SCEC – K&A Reviewed
Code B – Approved with Comments (Do not Resubmit)

PROJECT: JEDDAH OPERA HOUSE

TITLE: OPERA BUILDING
VERTICAL TRANSPORTATION
PART 001
PLANS - LIFT SHAFT (L07)

DRAWING No: JOH-OTS-S5-01-056-001-ZZ-SD-VT-011030 REV: S00

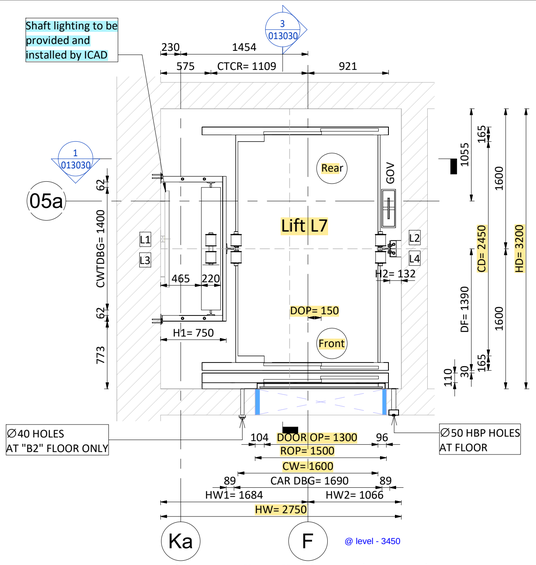
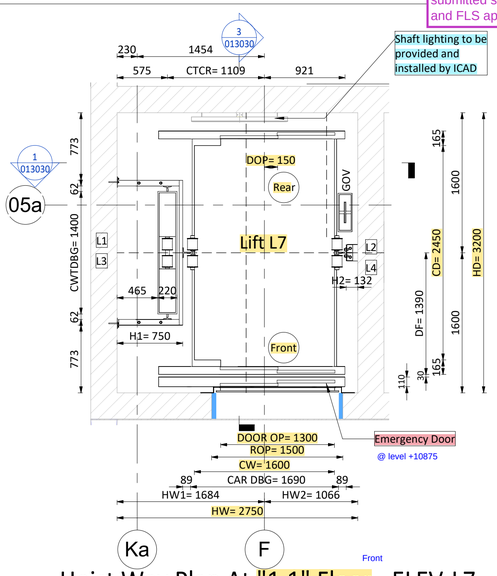
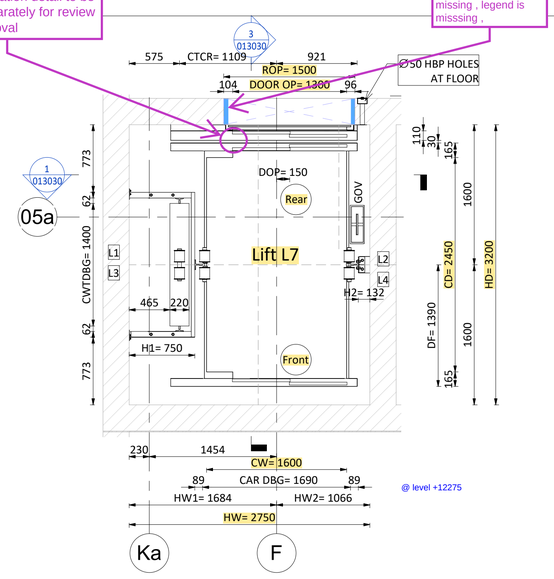
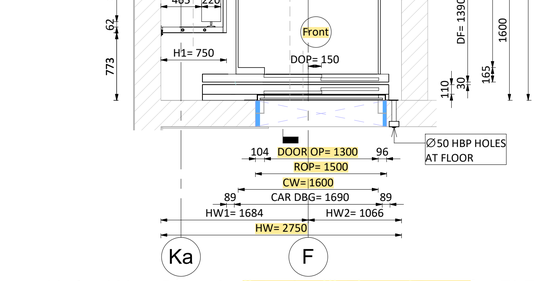
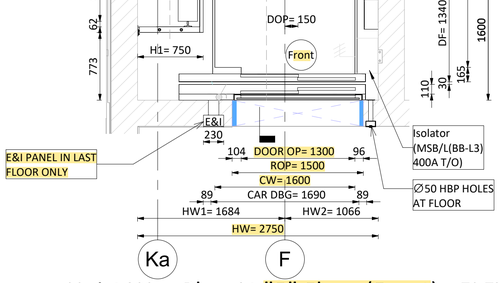
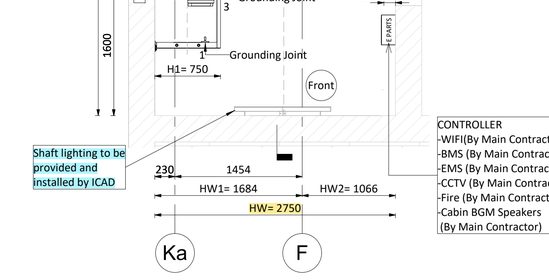
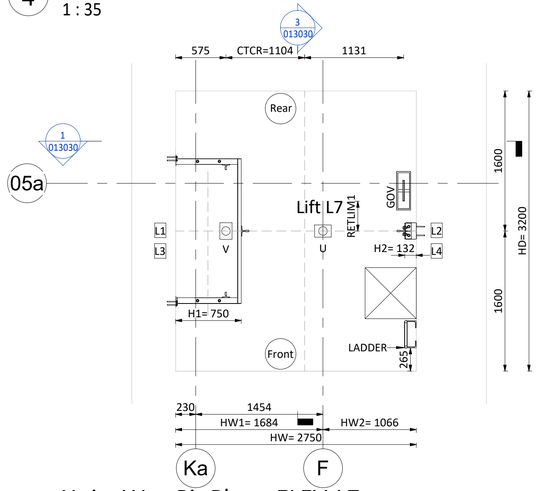
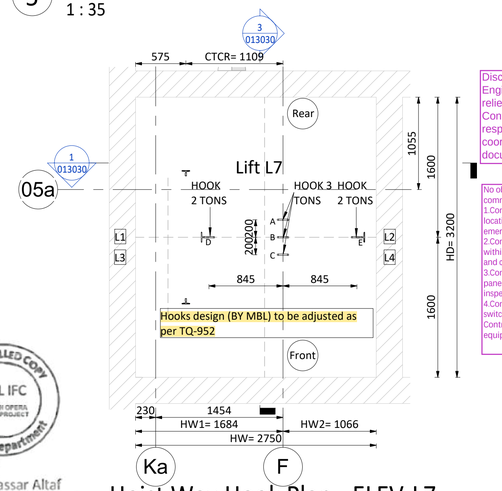
No objection from Electrical side with the following general comments:
1.Contractor to clarify lighting supply requirements and provide locations and provisions for shaft lighting, cabin lighting, emergency lighting, and ventilation fans.
2.Contractor to confirm compatibility with other interfaced systems within the project: BMS, PMS, CCTV, Fire alarm system, Intercom, and cabin speakers as noted on drawings.
3.Contractor to submit wiring diagrams for controller, car operating panel (COP), hall position indicators (HBP), and emergency & inspection panels (E&I).
4.Contractor to clarify the requirements for pit inspection reset switch and fireman service switch installations. (If any Contractor to Provide grounding and earthing details for elevator equipment, guide rails, and machine component.

9-this note is rejected , it is contractor sole responsibility to submit a complete coordinated shop-drawing connection details with wall finishes ,architraves floor threshold connection and liner/top door connection

1-shaft size to be extracted from federated model
2-contractor must take in consideration as built dimensions and conditions prior execution
3- FFL Levels shall match the federated model levels and as per site conditions
4- Elevator Car Sizes/**dimensions** and Floors Being Served by the Elevators shall be as per approved TBE and further to OTIS letter **TQ-05809** and lift deviation letter ref:**TQ-OPE-MBL-JCDC-01330**
5- car interior finishes shall be submitted in a separate submission for approval
6-HOISTWAY PRESSURIZATION is not provided contractor shall confirm its requirement prior execution
7-Contractor to update the missing reference when submitting the coordination drawing with wall finishing
8-hoistway entrance to be verified by contractor by the contractor to align with OTIS proposed drawings
9-stair ladder shall be submitted separately for approval
Structural comments:
8-Structural design of brackets including their anchor bolts into the concrete walls for the lift loads is to be submitted for checking and approval.

Otherwise, evident for its adequacy is to be provided.

MBL to provide a comprehensive Method Statement describing the procedure for filling all gaps and correcting / adjusting the rough openings for doors

missing information and include only the related TQ

add the letter references TQ-05809 & deviation letter

DRAWING No: JOH-OTS-S5-01-056-001-ZZ-SD-VT-012030 REV: S00

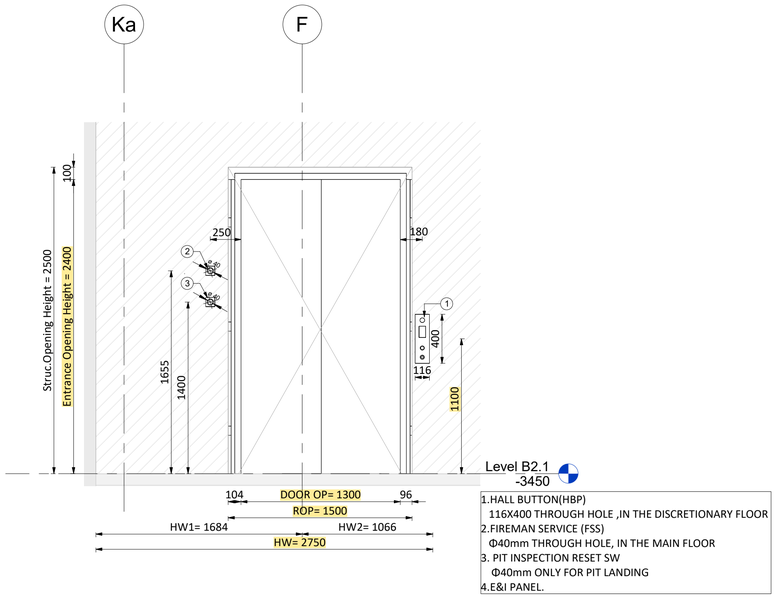
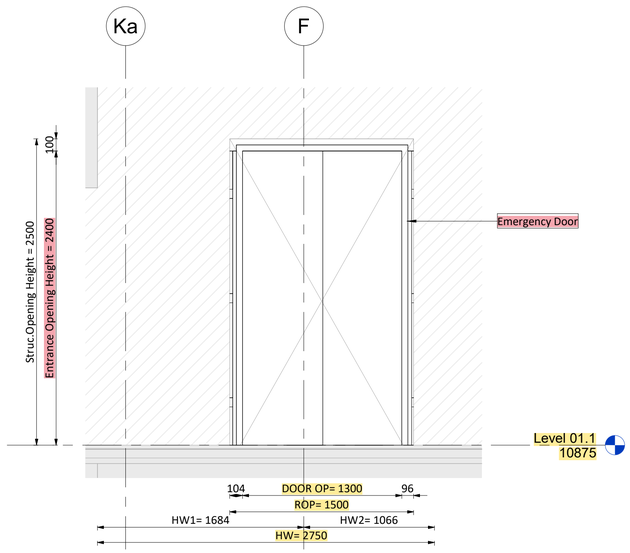
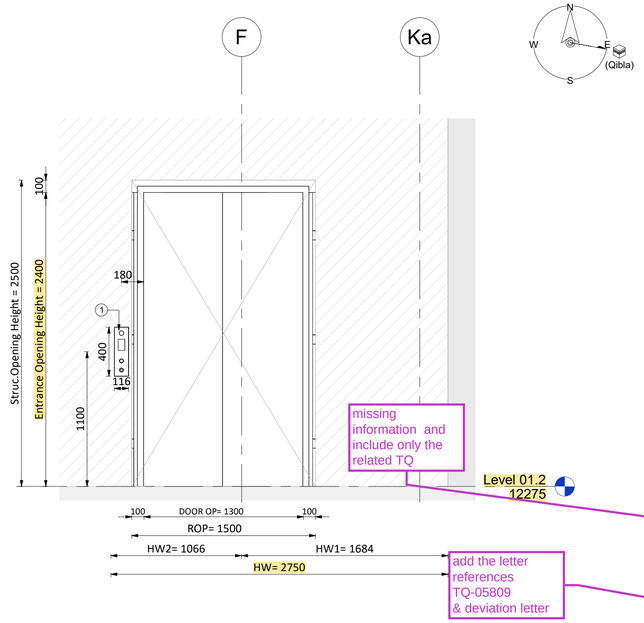
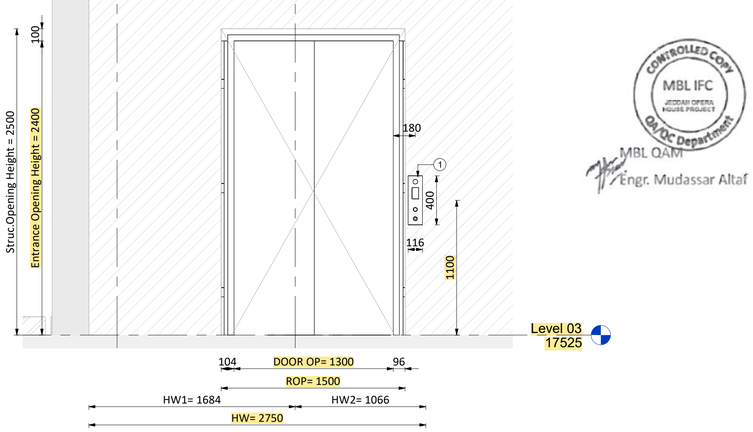
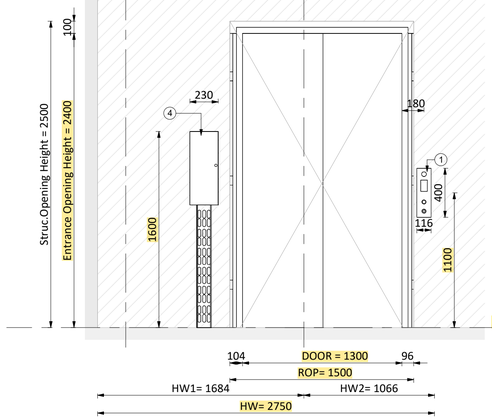
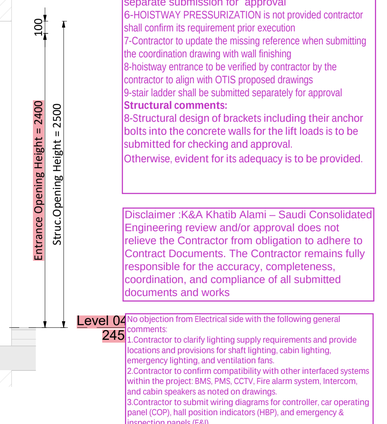
1-shaft size to be extracted from federated model
2-contractor must take in consideration as built dimensions and conditions prior execution
3- FFL Levels shall match the federated model levels and as per site conditions
4- Elevator Car Sizes/**dimensions** and Floors Being Served by the Elevators shall be as per approved TBE and further to OTIS letter **TQ-05809** and lift deviation letter ref:**TQ-OPE-MBL-JCDC-01330**
5- car interior finishes shall be submitted in a separate submission for approval
6-HOISTWAY PRESSURIZATION is not provided contractor shall confirm its requirement prior execution
7-Contractor to update the missing reference when submitting the coordination drawing with wall finishing
8-hoistway entrance to be verified by contractor by the contractor to align with OTIS proposed drawings
9-stair ladder shall be submitted separately for approval
Structural comments:
8-Structural design of brackets including their anchor bolts into the concrete walls for the lift loads is to be submitted for checking and approval.

Otherwise, evident for its adequacy is to be provided.

No objection from Electrical side with the following general comments:
1.Contractor to clarify lighting supply requirements and provide locations and provisions for shaft lighting, cabin lighting, emergency lighting, and ventilation fans.
2.Contractor to confirm compatibility with other interfaced systems within the project: BMS, PMS, CCTV, Fire alarm system, Intercom, and cabin speakers as noted on drawings.
3.Contractor to submit wiring diagrams for controller, car operating panel (COP), hall position indicators (HBP), and emergency & inspection panels (E&I).
4.Contractor to clarify the requirements for pit inspection reset switch and fireman service switch installations. (If any Contractor to Provide grounding and earthing details for elevator equipment, guide rails, and machine component.

MBL to provide a comprehensive Method Statement describing the procedure for filling all gaps and correcting / adjusting the rough openings for doors

DRAWING No: JOH-OTS-S5-01-056-001-ZZ-SD-VT-013030
REV: S00

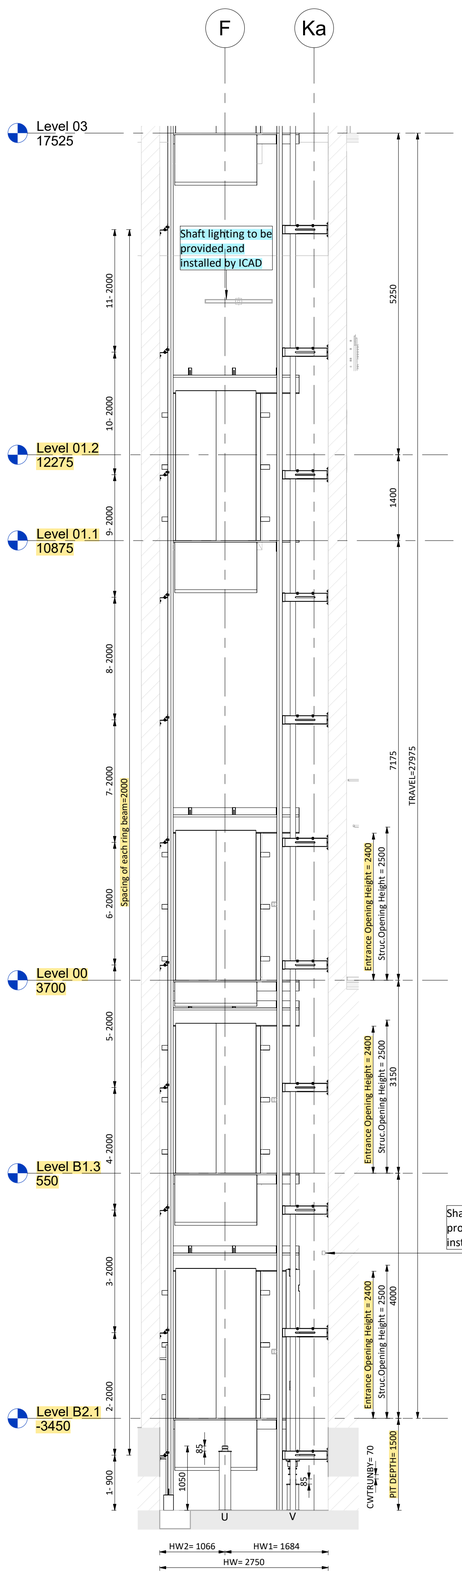
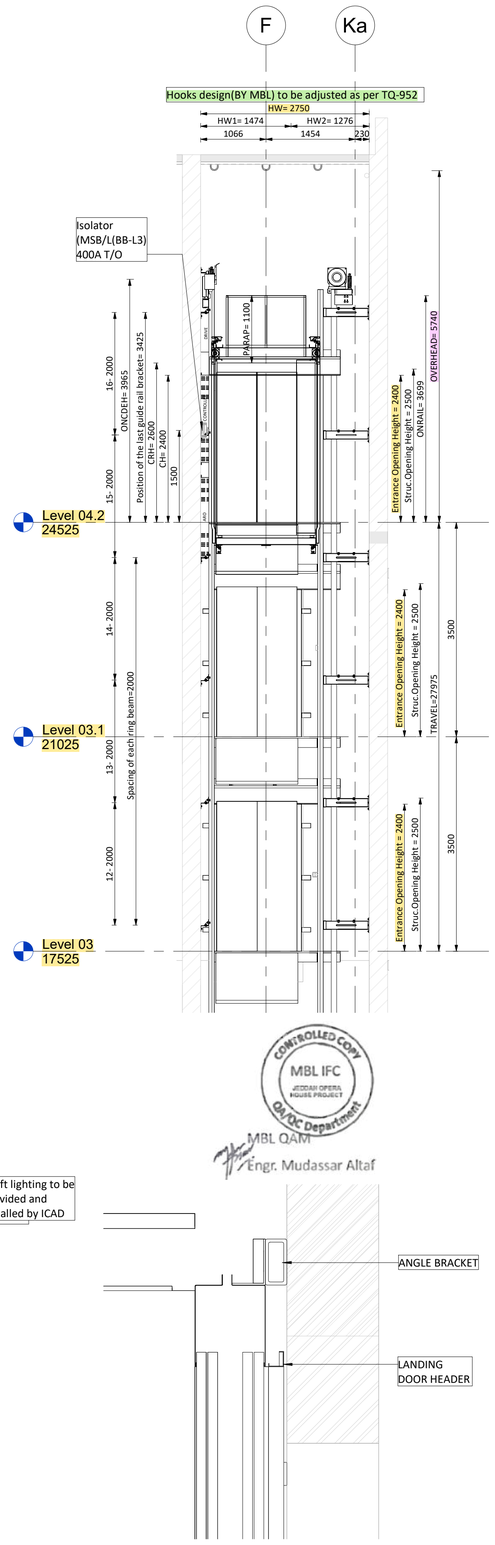
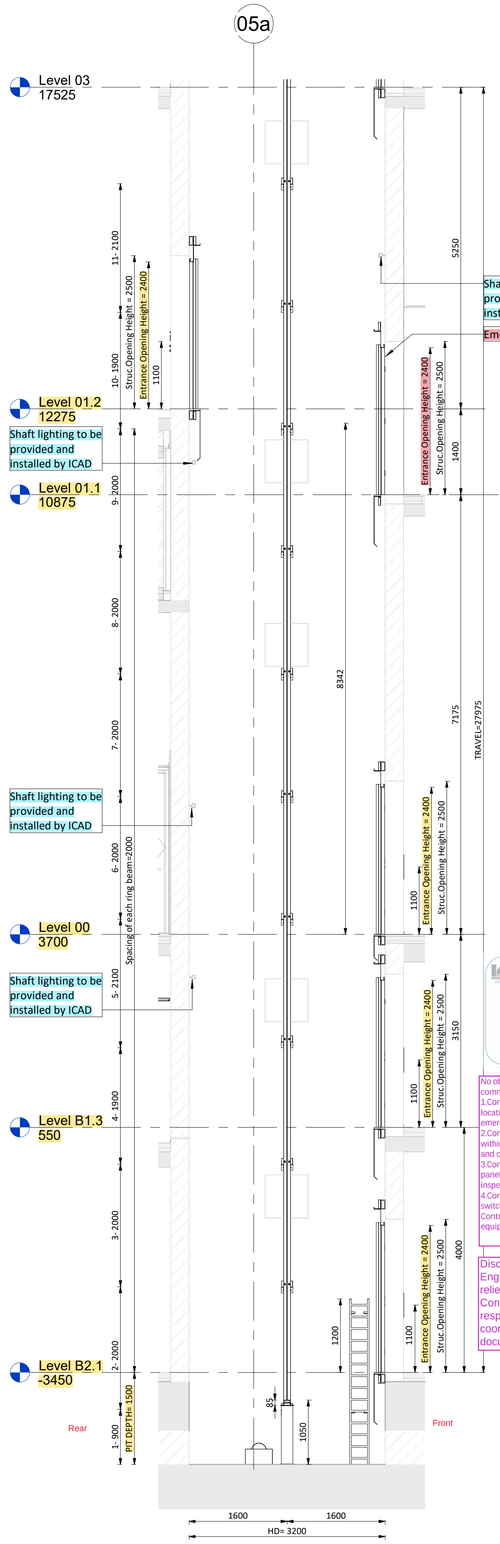
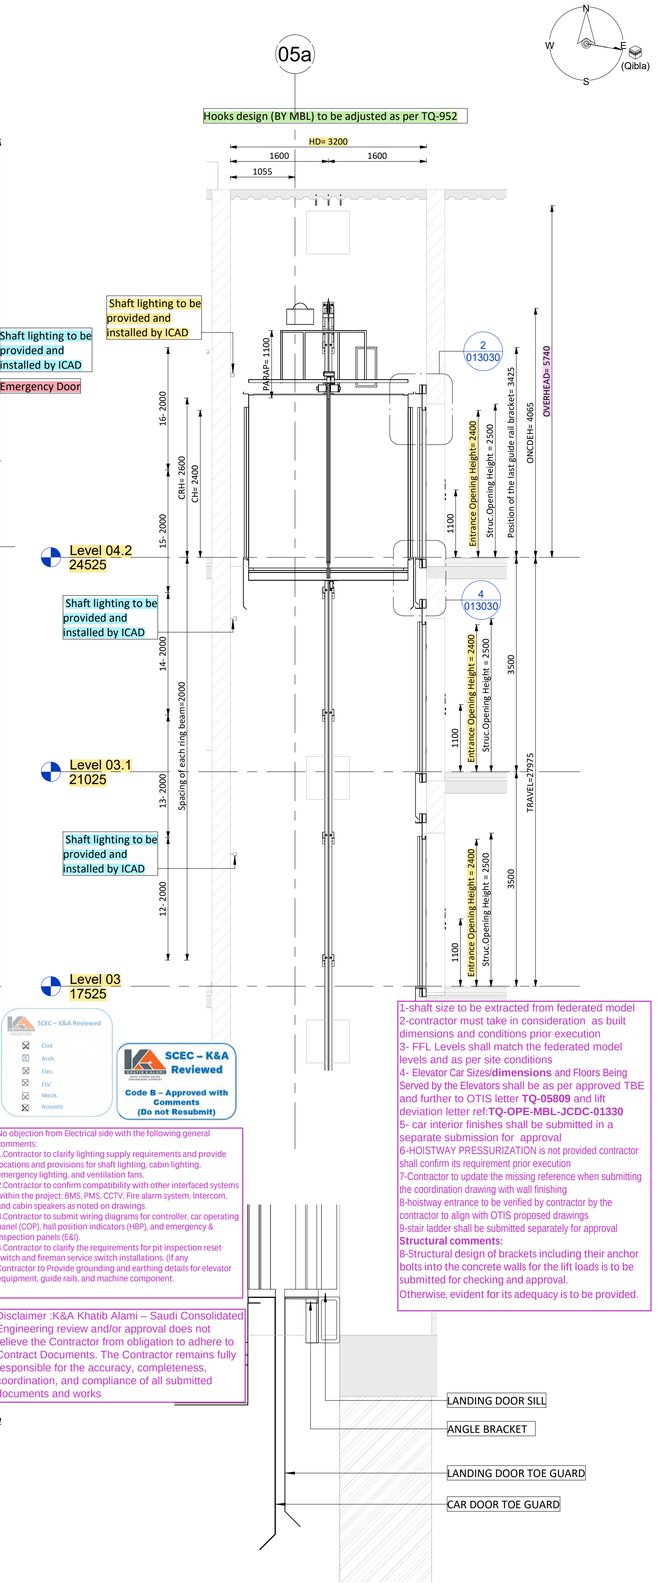
No objection from Electrical side with the following general comments:
1.Contractor to clarify lighting supply requirements and provide locations and provisions for shaft lighting, cabin lighting, emergency lighting, and ventilation fans.
2.Contractor to confirm compatibility with other interfaced systems within the project: BMS, PMS, CCTV, Fire alarm system, Intercom, and cabin speakers as noted on drawings.
3.Contractor to submit wiring diagrams for controller, car operating panel (COP), hall position indicators (HBP), and emergency & inspection panels (E&I).
4.Contractor to clarify the requirements for pit inspection reset switch and fireman service switch installations. (If any Contractor to Provide grounding and earthing details for elevator equipment, guide rails, and machine component.

1-shaft size to be extracted from federated model
2-contractor must take in consideration as built dimensions and conditions prior execution
3- FFL Levels shall match the federated model levels and as per site conditions
4- Elevator Car Sizes/**dimensions** and Floors Being Served by the Elevators shall be as per approved TBE and further to OTIS letter **TQ-05809** and lift deviation letter ref:**TQ-OPE-MBL-JCDC-01330**
5- car interior finishes shall be submitted in a separate submission for approval
6-HOISTWAY PRESSURIZATION is not provided contractor shall confirm its requirement prior execution
7-Contractor to update the missing reference when submitting the coordination drawing with wall finishing
8-hoistway entrance to be verified by contractor by the contractor to align with OTIS proposed drawings
9-stair ladder shall be submitted separately for approval
Structural comments:
8-Structural design of brackets including their anchor bolts into the concrete walls for the lift loads is to be submitted for checking and approval.

Otherwise, evident for its adequacy is to be provided.
